INITIAL FIRE SAFETY INSPECTION REPORT

Reedisha Knitex Ltd. (Extension)

RSC ID: 24600

Date: 05-Dec-2023

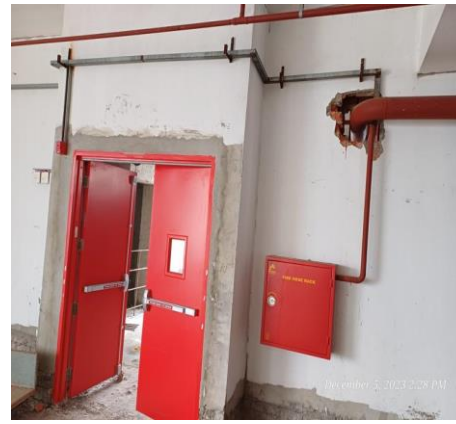
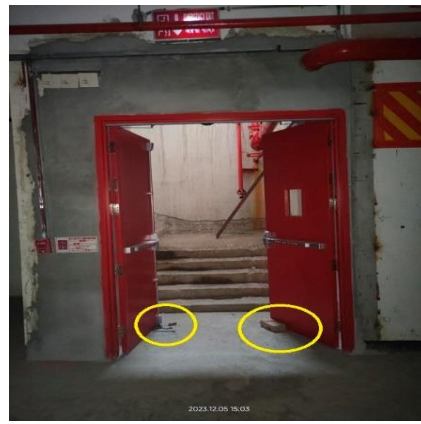
SI No.	Category	Findings	Required Action	Remediation Time Frame
F-1	Fire Rated Construction	The exit stairs are not separated from work areas, other spaces on each floor by fire-rated construction due to non-functioning door accessories, listing information missing on accessories, door were kept open by external source & unprotected penetration. Location: Building-11	Provide minimum 2-hr fire rated construction for buildings 4 storied or more and 1-hr for up to 3 storied. Seal all unprotected openings to separate the exit stairs from work areas and other spaces on all floor levels by 90 minutes for 2 hr. construction and 60 minutes for 1-hr construction. Ensure that the fire rated doors are self-closing and positive latching and that they are provided with fire exit (panic) hardware where serving production floors. If fire rated doors are required to be held open for functional reasons, provide automatic closing devices tied to the fire alarm system.	Within 3 months

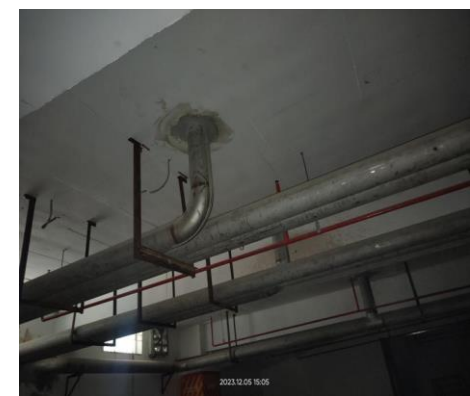
F-3	Fire Rated Construction	Penetrations through floor/ceiling assemblies are found unsealed. Location(s): Plumbing pipes and Electrical Riser, Basement store steel & sanitary pipes etc. (Building-11)	Provide a minimum 2-hr fire-rated shaft to separate the utility risers from each floor level or seal all penetrations and openings in floors/ceiling assemblies by 3-hr fire-rated listed/certified materials. The installation of such fire-rated materials shall be following certified design.	Within 3 months
-----	-------------------------	---	--	-----------------

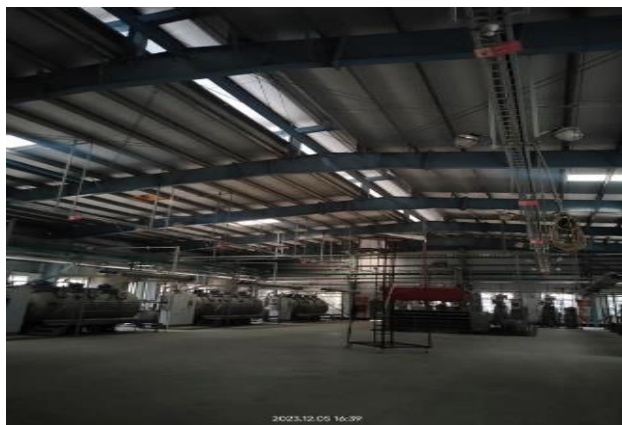
F-14	Emergency Lighting	Based on the number and location of emergency lights observed, adequate illumination levels are not anticipated along egress routes and at exit stairs. Location: All Buildings	Test the emergency lighting system on each floor and provide additional emergency fixtures to supply adequate illumination along the means of egress. Provide a minimum illumination of 10 lux at the floor level within exit stairs and along exit discharge paths and a minimum 2.5 lux along exit access aisles.	Within 1 month
------	--------------------	--	--	----------------

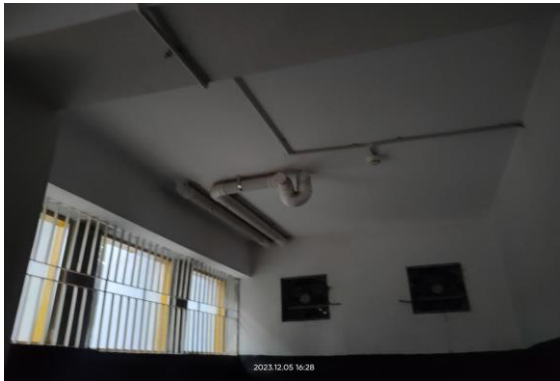
F-30	Fire Rated Construction	Chemical store was found on the ground floor without fire separation due to unprotected penetration due to sanitary pipes & opening has been observed with the Dyeing section. Location: Building-10	Ensure the chemical store fire separated by minimum 4-hr fire rated construction barrier with only occupancies with G and H following table 3.2.1 of BNBC-2020. No opening is permitted in the 4-hr rated wall towards any other occupancy. Follow section 2.13 of BNBC-2020 as a guideline chemical store while rearranging.	Within 3 months

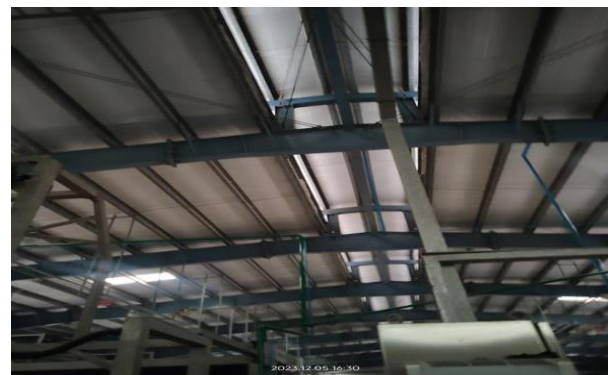
F-32	Fire Rated Construction	The main structural element of the Single storey dyeing shed by steel which is non-rated & building height is 11.2m. Steel members were found in exposed condition without any fire protection. Location: Building-10	The building shall be type 1-C construction as per RSC Technical Guidelines (Standard) 3.5.2 & BNBC 2020. Provide require rating in the structural elements of the building. Consult with a qualified fire protection engineer. Submit the proposed drawing/design to RSC for review. Once reviewed, install passive fire protection as per reviewed design.	Within 6 months
------	-------------------------	--	--	-----------------

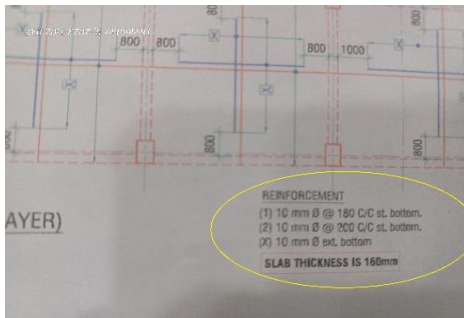
F-36	Fire Rated Construction	Rooms used for chemical storage are not properly separated by fire rated construction due to inadequate slab thickness (160 mm). Also sample room having large amount of chemical samples wasn't provided with proper MSDS to verify the quantity within allowable limit. Location: Ground floor, 1st floor and 2nd floor. 3rd & 4th floor (Sample and sub-store) of Building 5-Printing Building.	Provide a minimum 4-hr fire-rated construction barrier (For required slab thickness, follow Table 4.1.1- BNBC-2006) or other fire-rated listed/certified materials to separate the chemical stores from each floor level. The installation of such fire-rated materials shall follow a certified design. Provide MSDS, chemical category, and category-wise allowable limit for chemicals as per BNBC and manage all the chemicals in the sample and sub-store as per the allowable limit.	Within 3 months

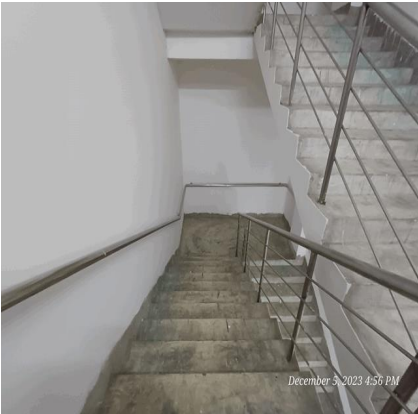
F-40	Fire Rated Construction	Penetrations through floor/ceiling assemblies are found unsealed due to sanitary pipe. Location(s): Building 5-Printing building	Provide a minimum 2-hr fire-rated shaft to separate the utility risers from each floor level or seal all penetrations and openings in floors/ceiling assemblies by 3-hr fire-rated listed/certified materials. The installation of such fire-rated materials shall be following certified design.	Within 3 months
